RHB 041 -80

MFN 104-80

SUBJECT: NRC REQUEST FOR ADDITIONAL INFORMATION, DFFR ROUND 2
QUESTIONS

NRC QUESTIONS DATED JANUARY 14, 1977, WITH RESPONSES

Figure 6. Drywell Pressure Short Term Response Recirculation Line Break - Susquehanna

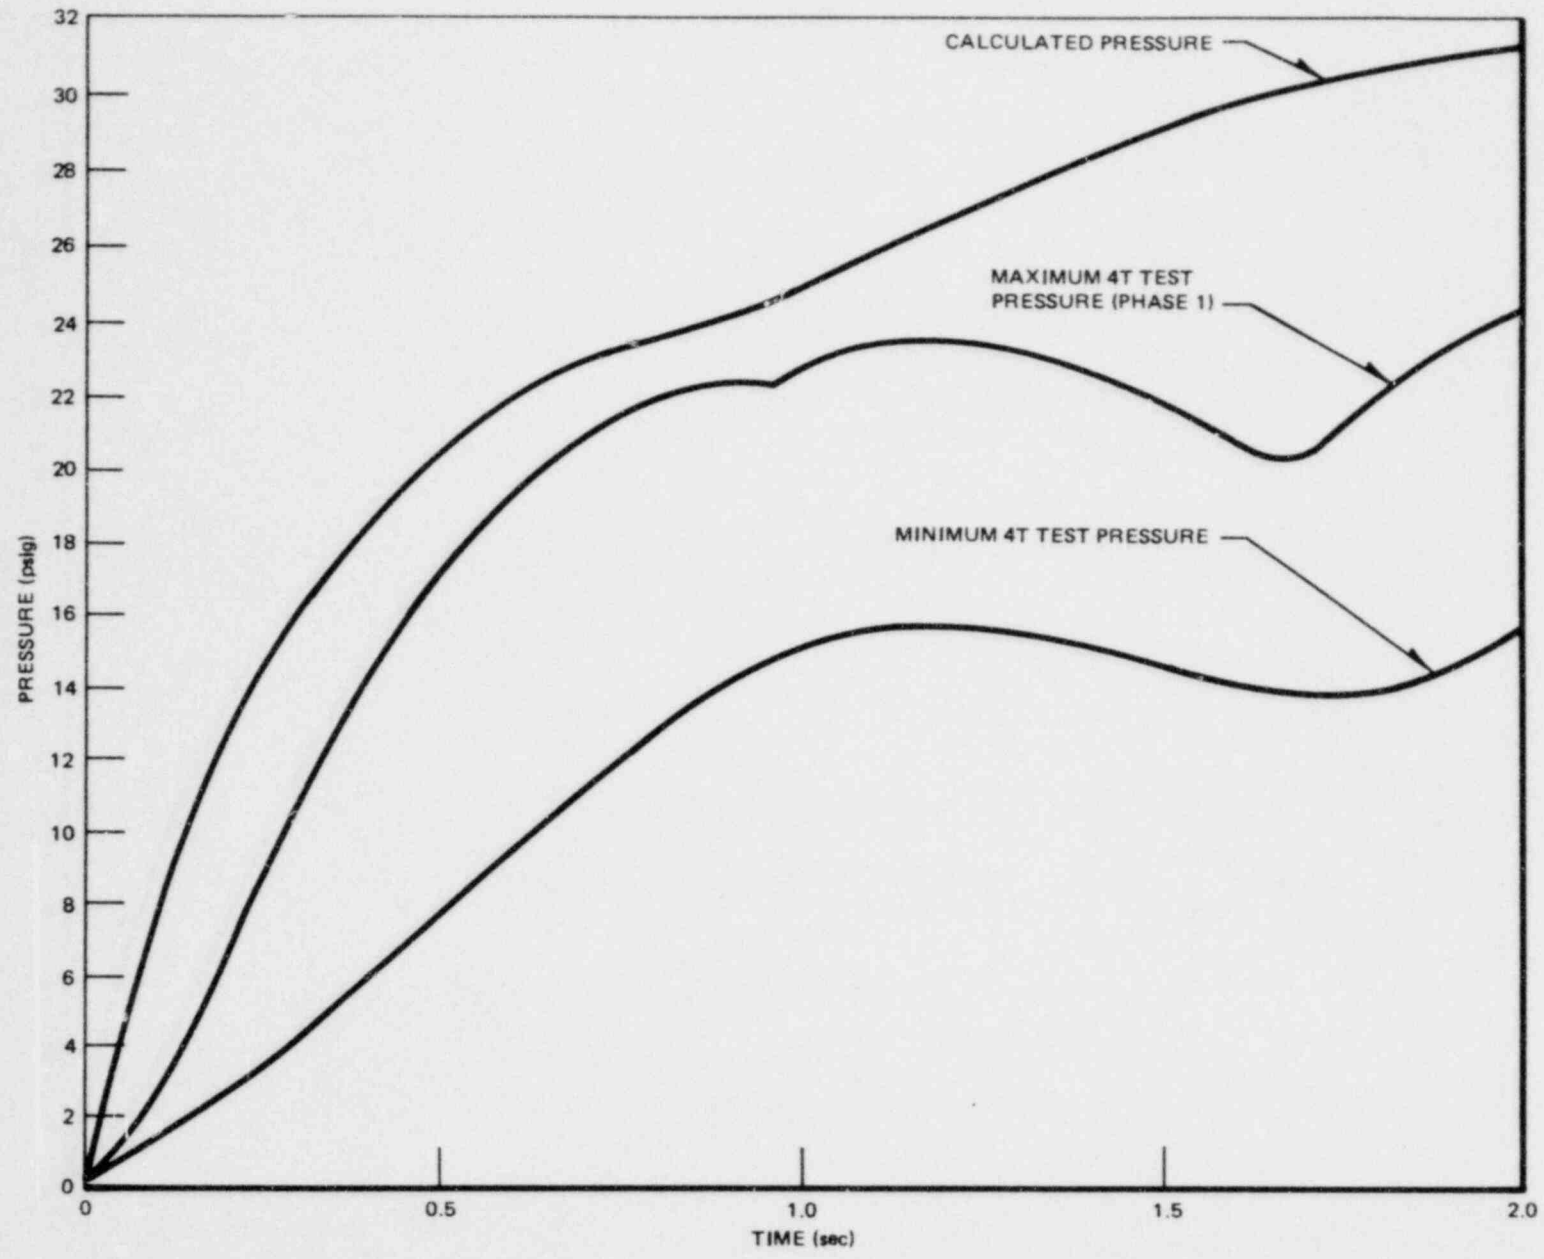
4. The calculated drywell pressure response and the enthalpy flux in the downcomer vent should be compared to the 4T 2-1/2 in. and 3 in venturi data.

The following figures 1 through 9 show comparisons between the drywell pressure transients calculated for each Mark II containment project and the bounding pressure traces from the applicable Phase 1 4T tests (NEDE-13442-P) (24-in. downcomer vents, closed tank, preheated drywell) over the period of interest for pool swell ($t < 2$ sec).
